NOTICE PLAN COMMISSION March 17, 2015

TO: Plan Commission
FROM: Tom Hovel, Zoning Administrator/City Planner
Susan Badtke, Community Planner
DATE: March 12, 2015
SUBJECT: March 17, 2015 Plan Commission Items

**Amendment to
Comprehensive Development Plan
Previously Approved
Under Resolution R-12-14
Quarry Vista
Fitchburg, Wisconsin**

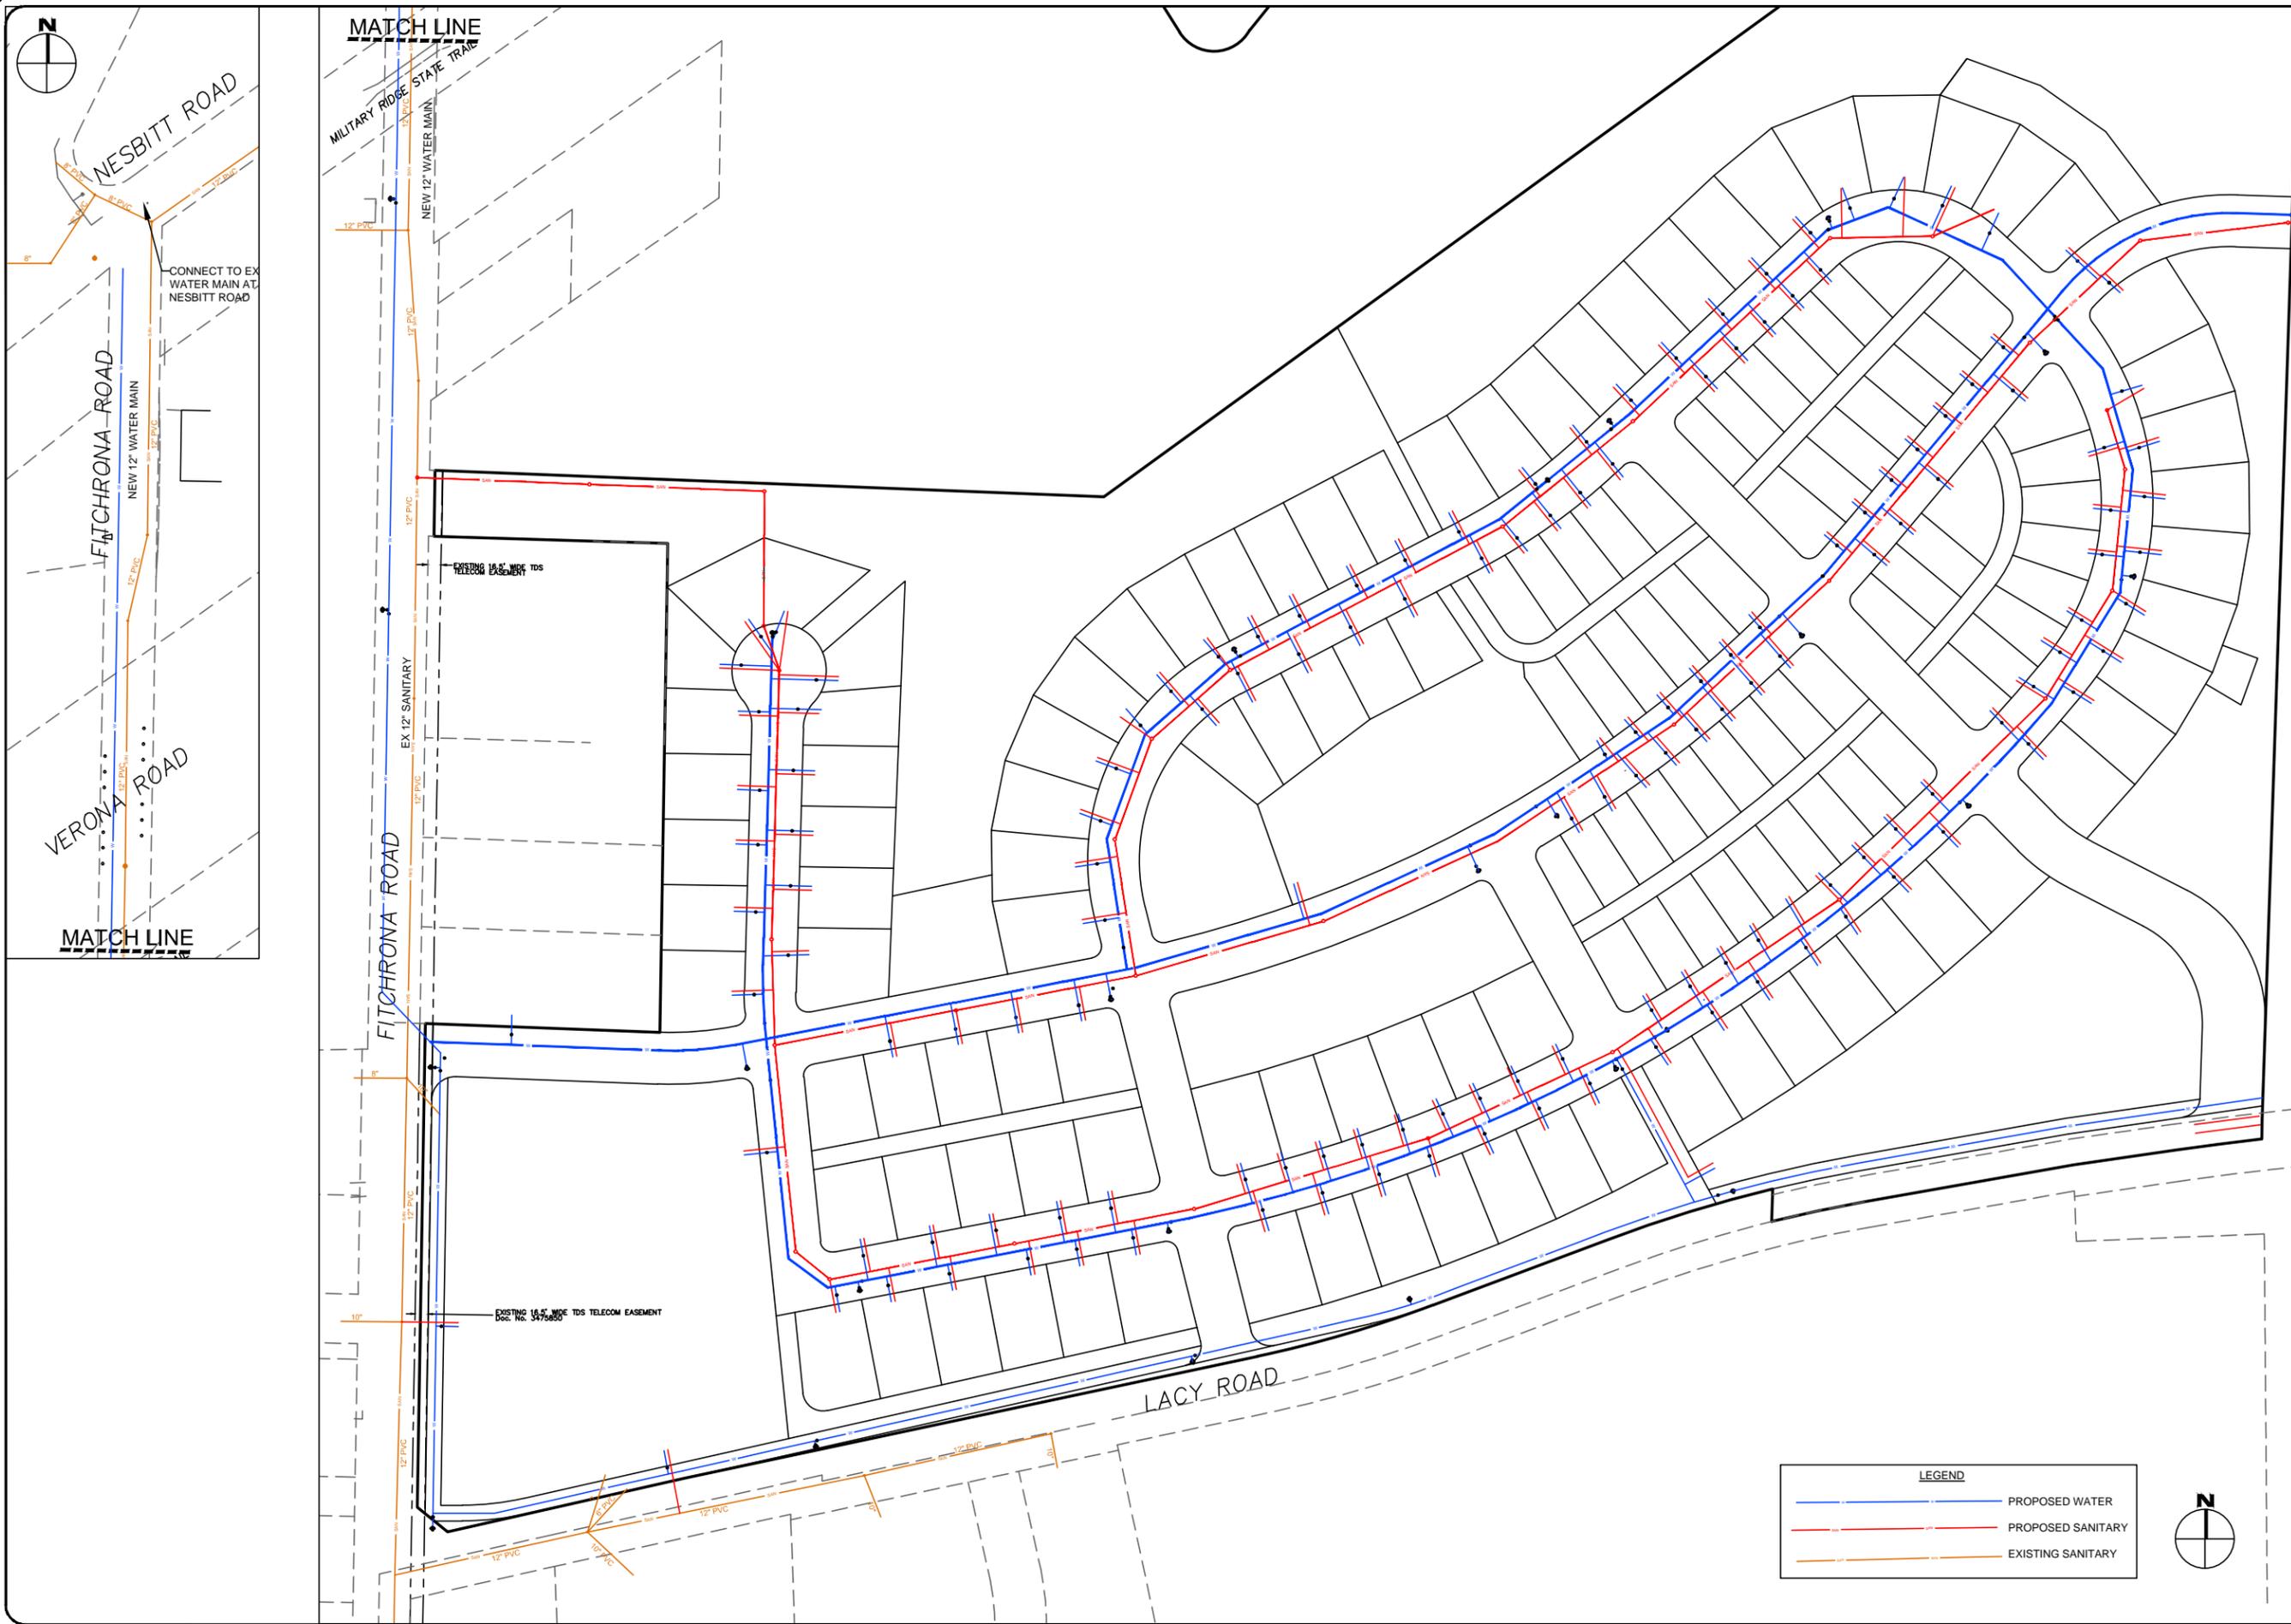
1. CDP – Figure 6
 - Water and sanitary sewer laterals are currently shown going into Outlot 5 (the proposed modified landfill area). Please remove the laterals to this Outlot. Please add water and sanitary lateral(s) to Outlot 3 for a potential future shelter/water fountain/bathroom facility.
 - Show water main to the eastern plat line along Lacy Road.

Response: Figure 6 has been revised as requested.
2. Preliminary Plat
 - Note 10 indicates dedication for “Outlots 10 and 12 for public water main purposes.” Did you mean Outlots 9, 10 and 11? **Response: Outlot numbers have been revised.**

- Provide a 30’ public water and sanitary easement on the plat between Lots 60 and 61 for water and sanitary service for Outlot 12 as shown in CDP Figure 6. **Response: We added a 30’ easement to serve Outlot 12 but added it between Lots 59 and 60. Figure 6 has been updated to reflect this location.**

FIGURE NO.
 7

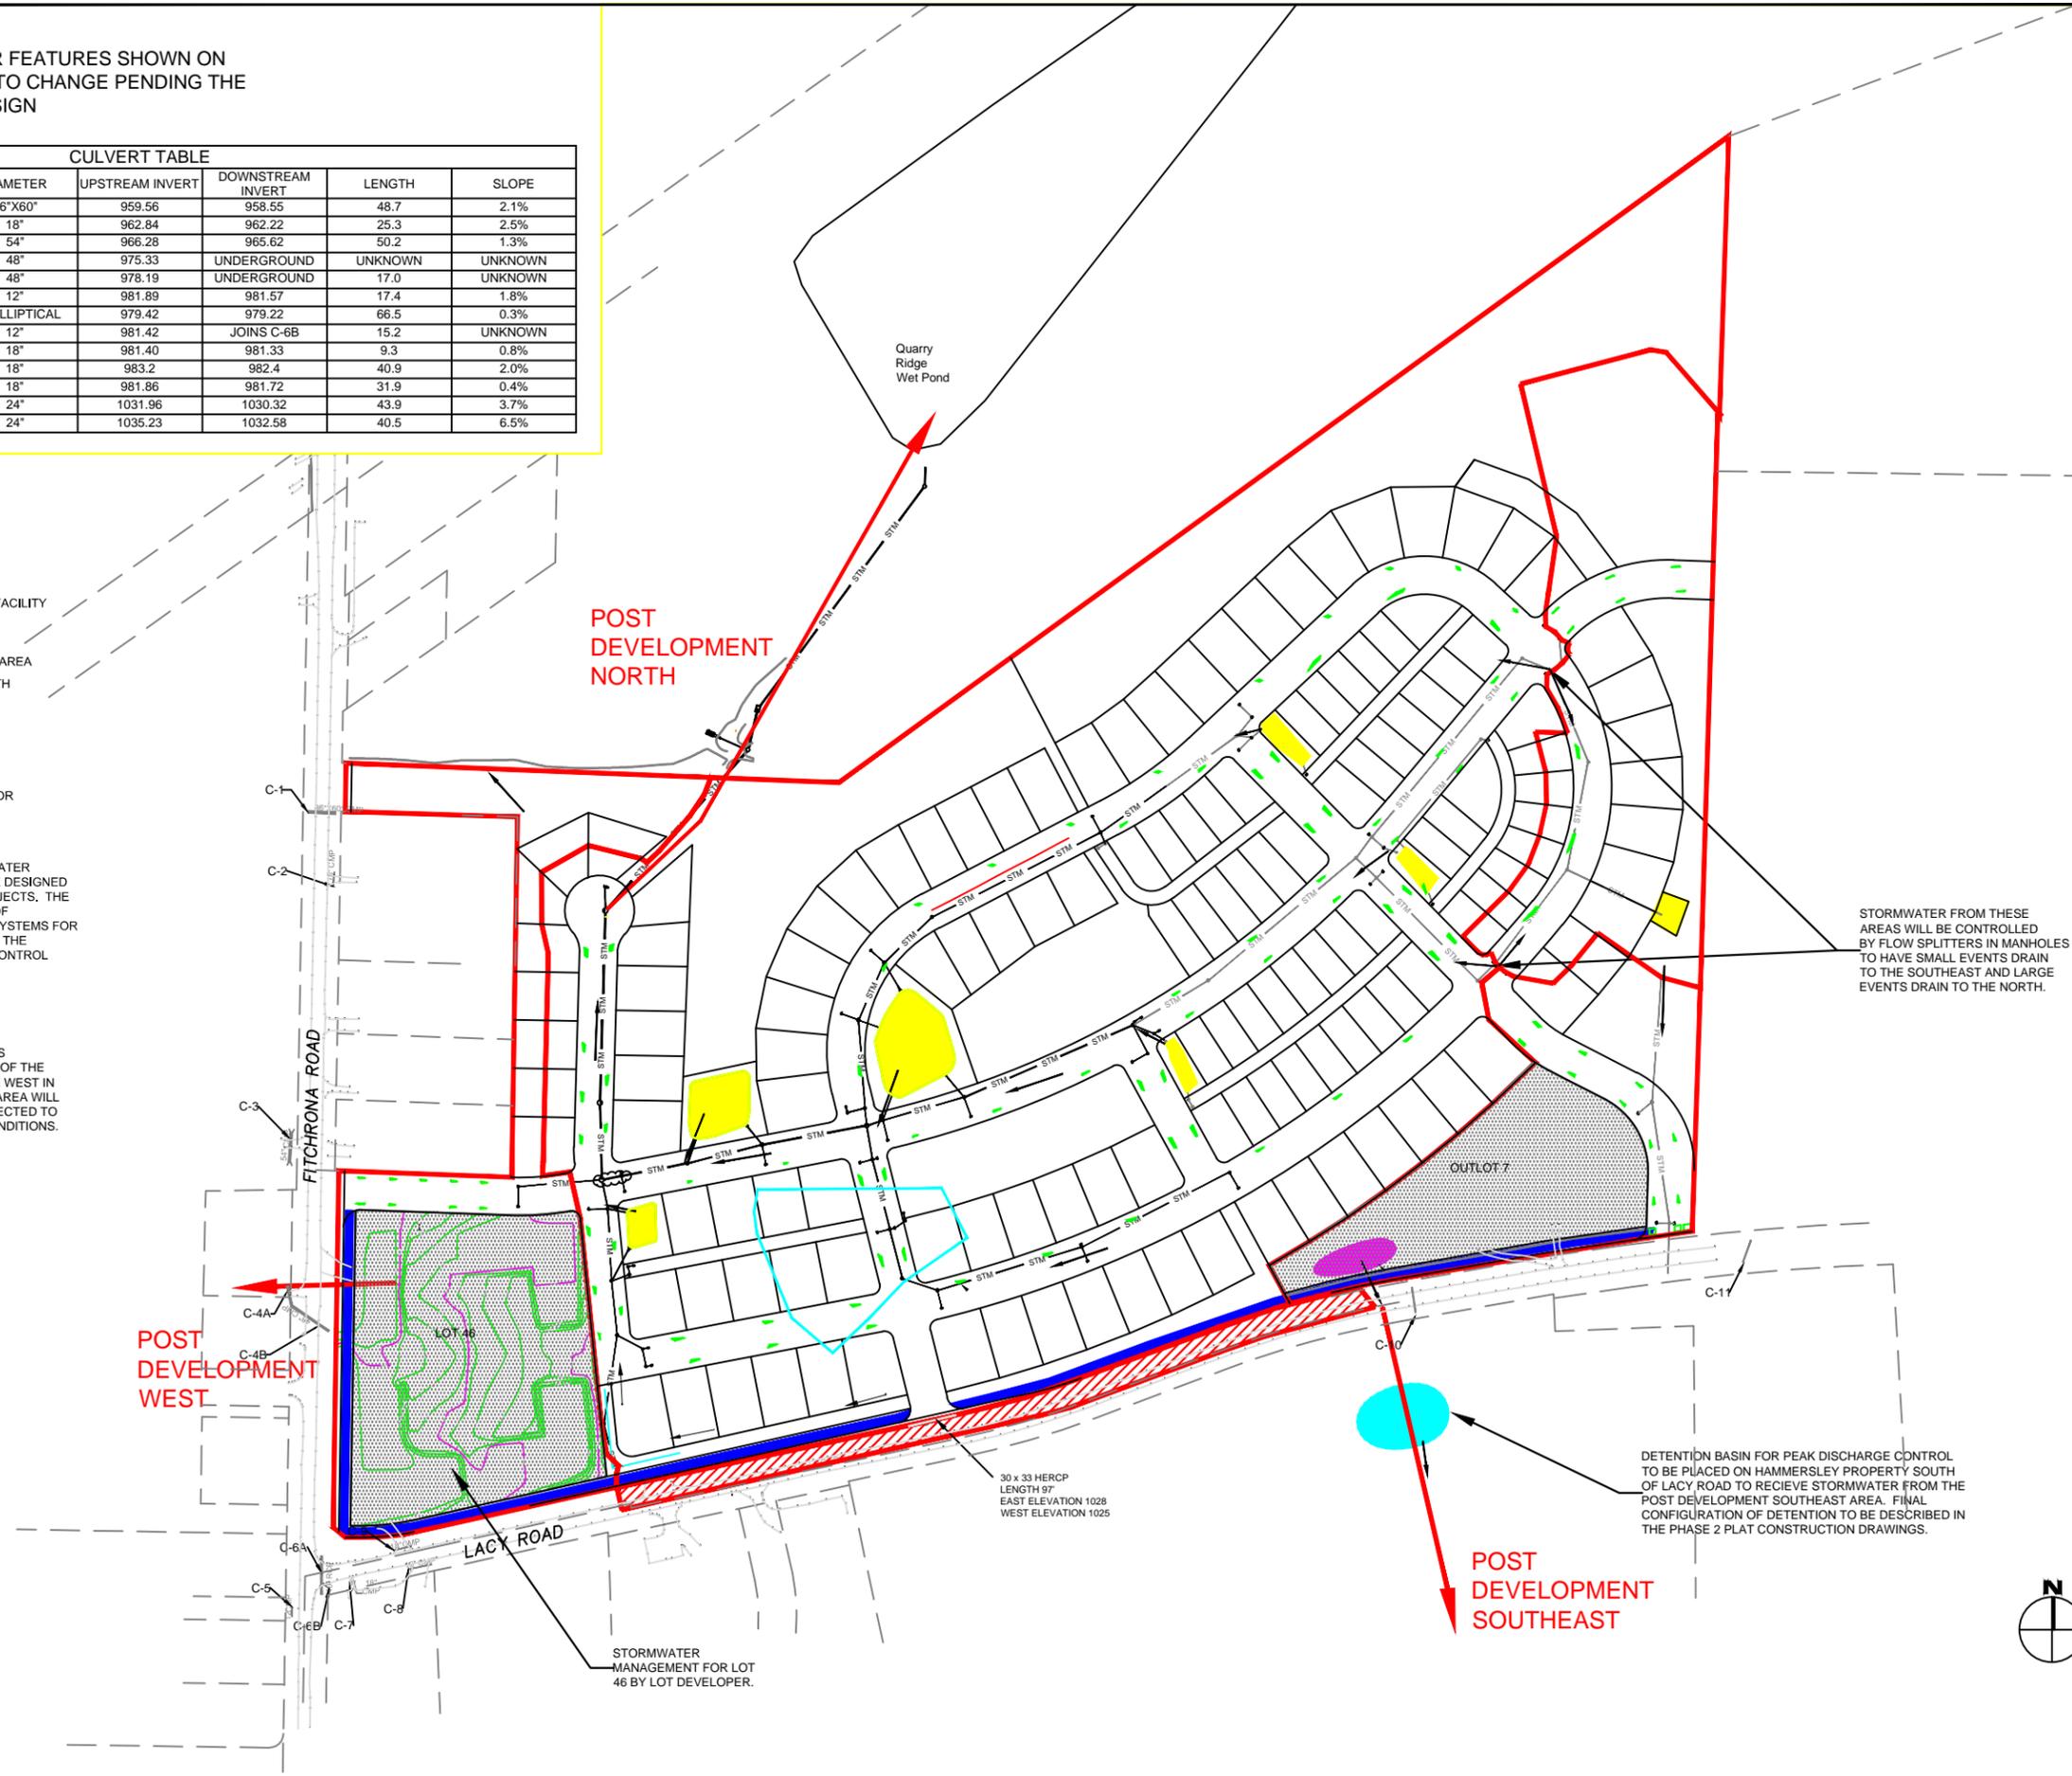
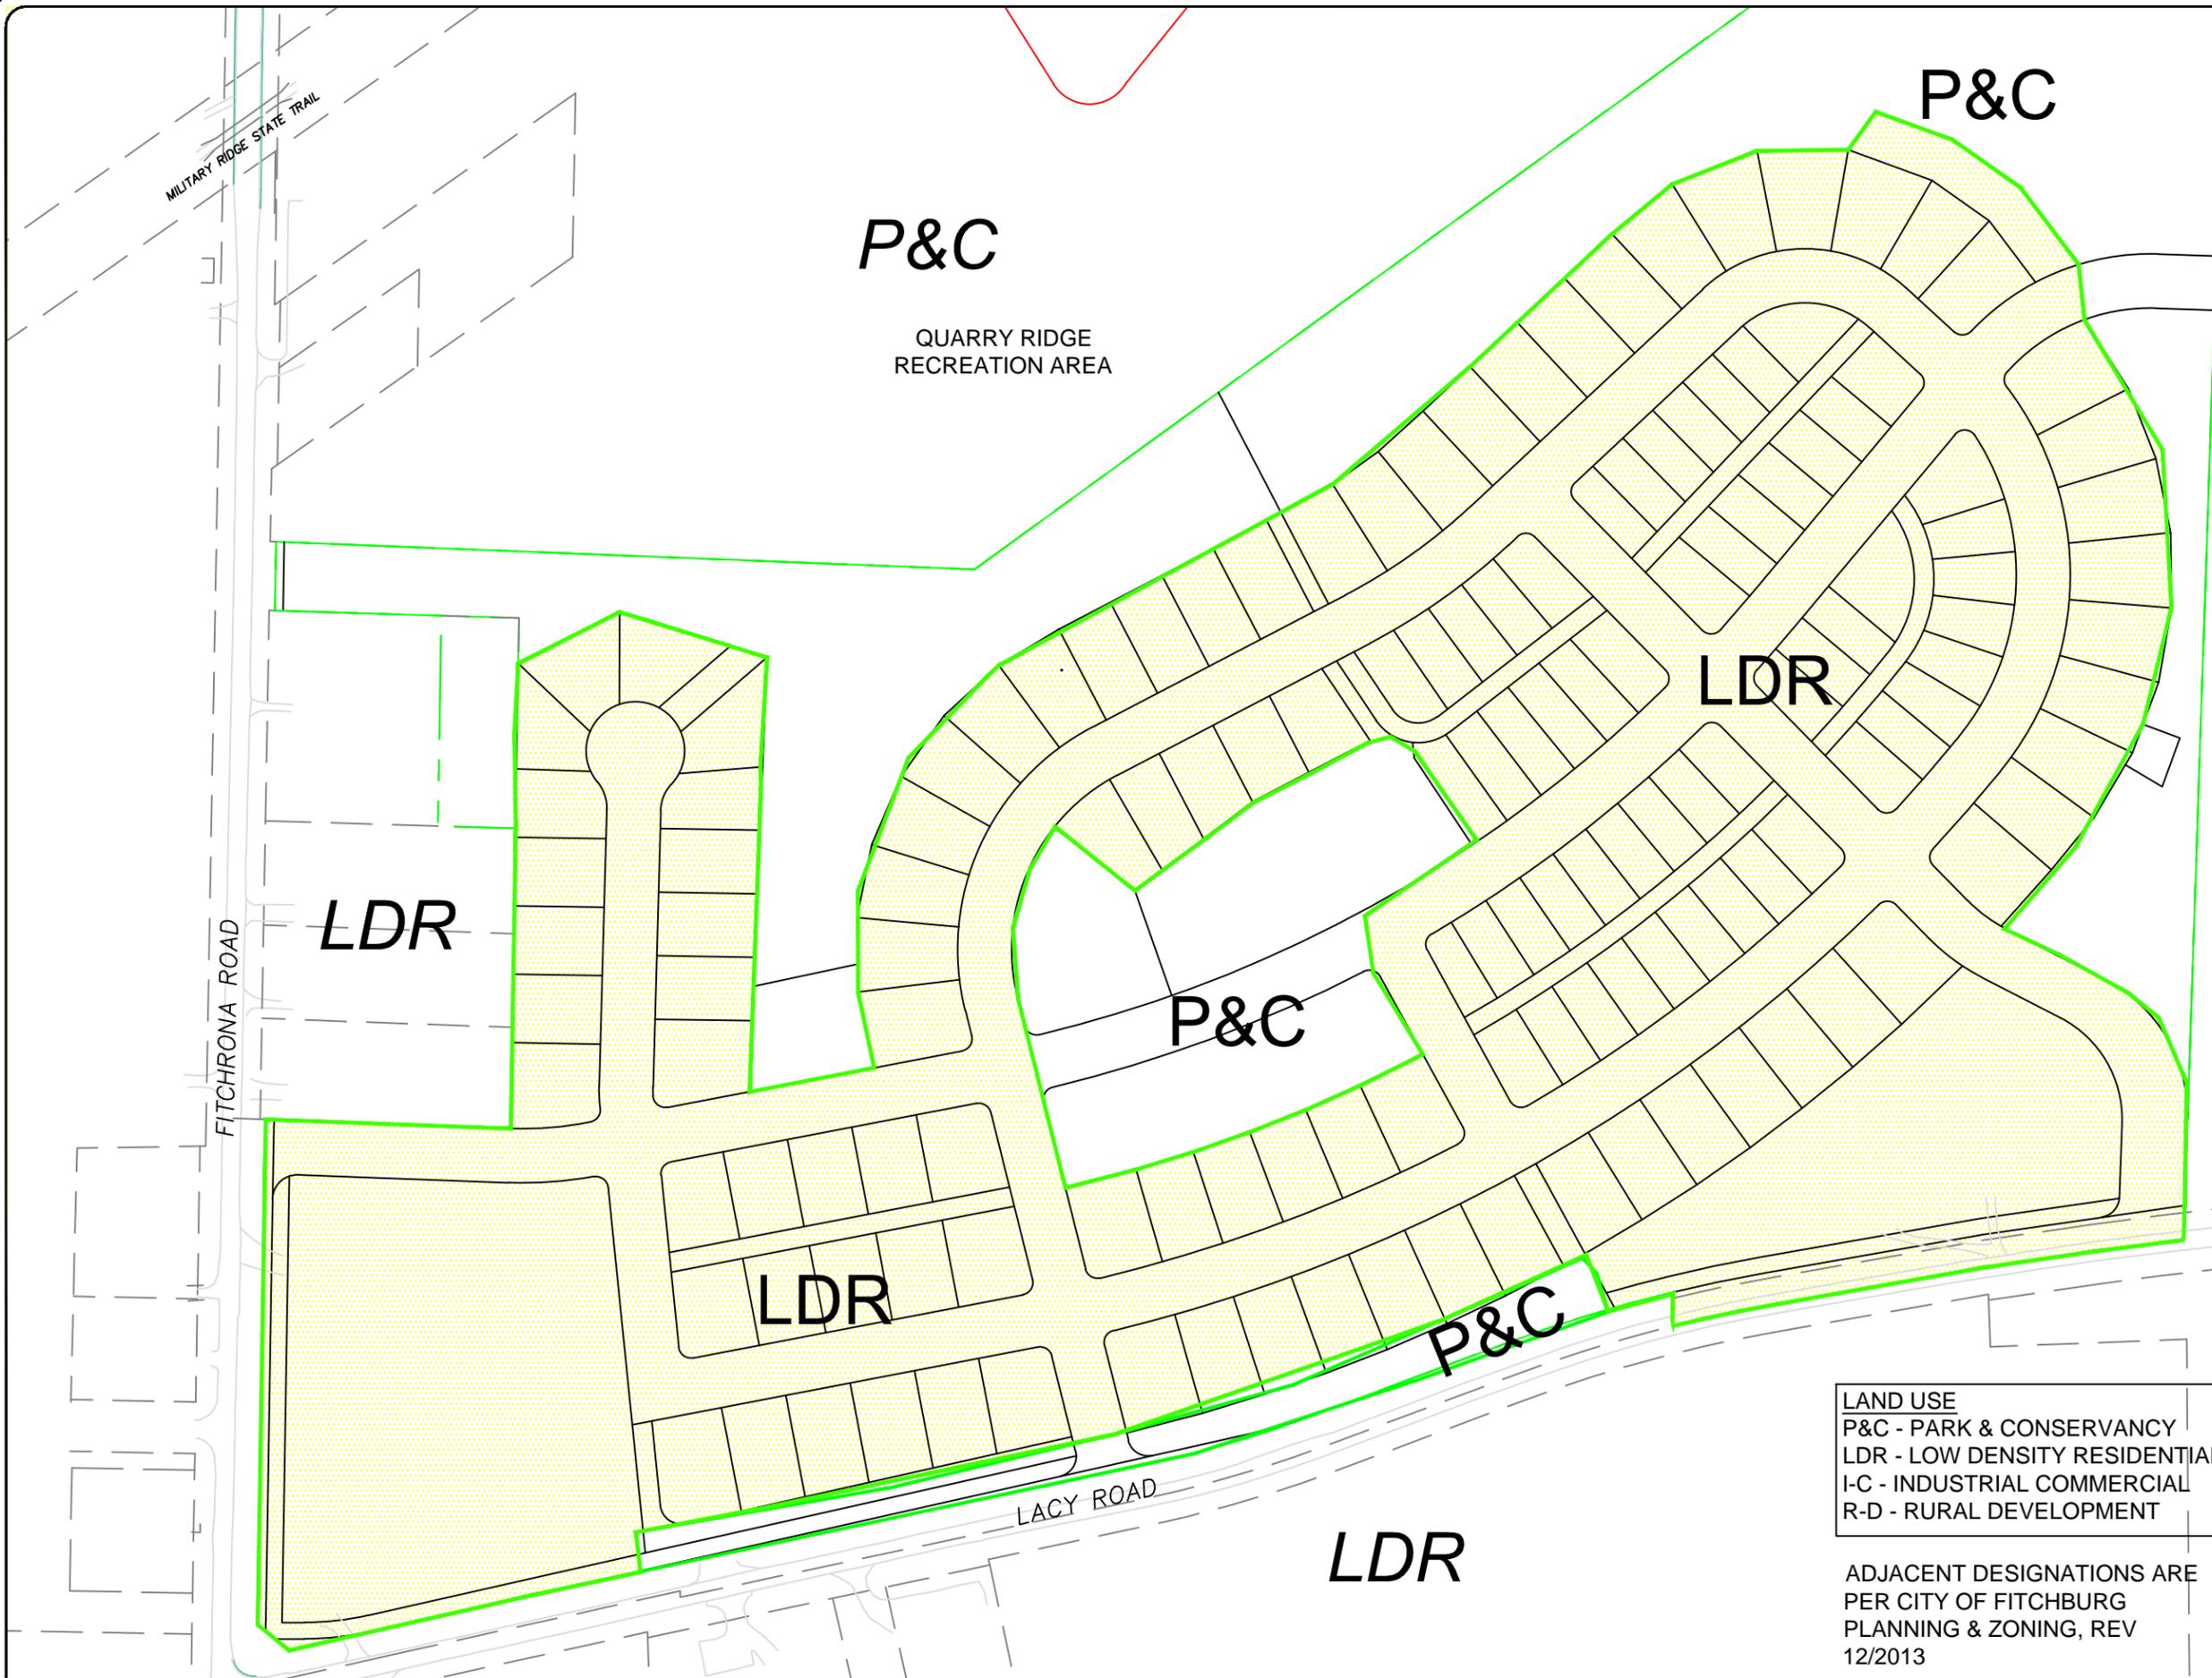
3. CDP – Figure 7 – Please update storm sewer pipe alignment from Turnstone Circle to Quarry Ridge Wet Pond based on the November 3, 2014 walk-through that Rick Eilertson and Scott Endl had with Russ Pietz (MARS). **Response: Figure 7 has been updated.**
